Effect of fixings on the performance of timber weatherboards

1 THE MATTERS TO BE DETERMINED

**SINGLE NAIL FIXING
AS REQUIRED BY NZS 3604***
(figure received from Territorial Authority)

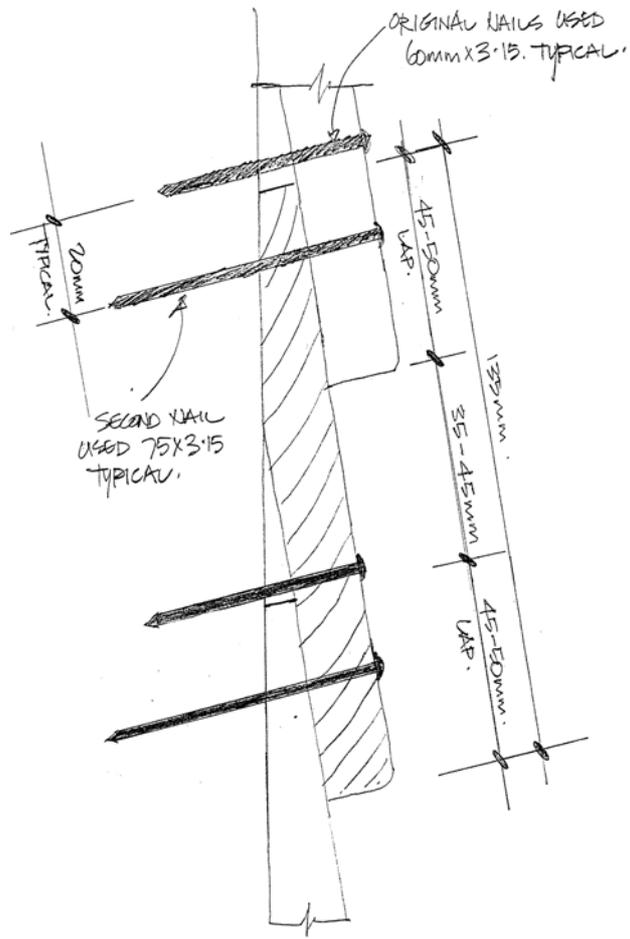
Single nail (75mm x 3.15mm) per board shall be located immediately above, but within 10mm of the top

- 5.1 The territorial authority said:
“Movements due to temperature and moisture are effectively restrained as a result of three point fixings. We are unsure of the long-term effects on the performance of weatherboards due to fixing and are unable to accept as code complying.”

- (a) Determines that, in this particular case, the fixing of the weatherboards is such that the exterior wall complies with clause E2.3.2 of the building code.
- (b) Reverses the territorial authority's decision to refuse to issue a code compliance certificate in respect of the fixing of the weatherboards.

**THREE NAIL FIXING
AS INSTALLED**
(figure received from owner)

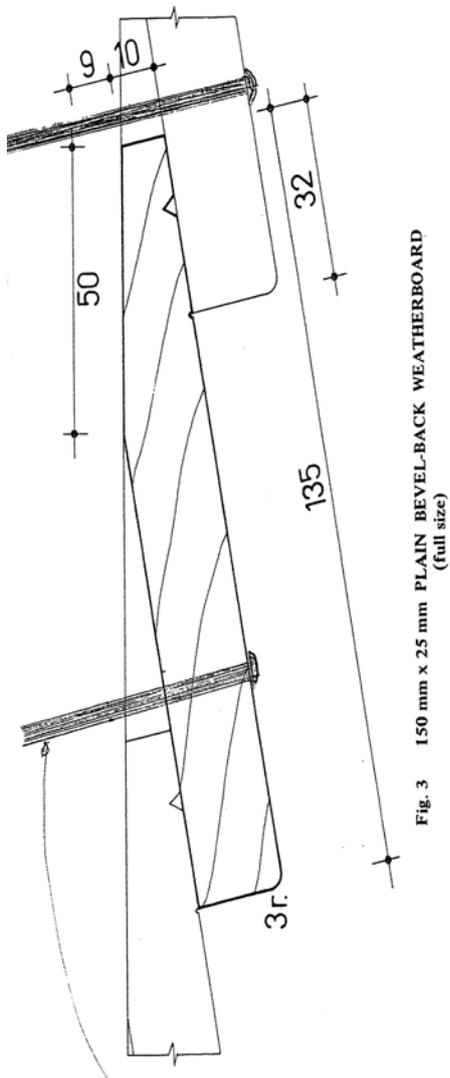
- “(a) If significant drying and splitting from shrinkage was going to occur, there would be evidence of that by now. However there was no evidence of splitting present, and only mild cupping.
- “(b) There is potential for perhaps another 3% drying, at worst, and that is unlikely to bring about serious and extensive failure.
- “(c) If further drying did cause splitting, then this is likely to be limited in extent, would be readily noticeable and could be attended to as maintenance before any more consequential failure occurred. . . .
- “(d) In my opinion, in this particular situation, it is unlikely that the unconventional nailing of the weatherboards will bring about a failure to comply with the performance requirements of the N Z Building Code but this opinion remains valid only if the issues listed below are addressed.”

- 6.1 The Authority accepts that, as indicated by the Authority’s consultant, that the weatherboards have now “settled down” and are likely to experience comparatively little future expansion and contraction when they are wetted by rain or when the ambient temperature and humidity change.
- 6.2 The Authority accordingly considers that, with normal maintenance ensuring that the weatherboards continue to be protected by paint (preferably of a light colour), the unconventional fixing is unlikely to result in significant future cupping or cracking.
- 6.3 The Authority concludes that, in the particular circumstances concerned, the unconventional fixing of the weatherboards complies with the building code.
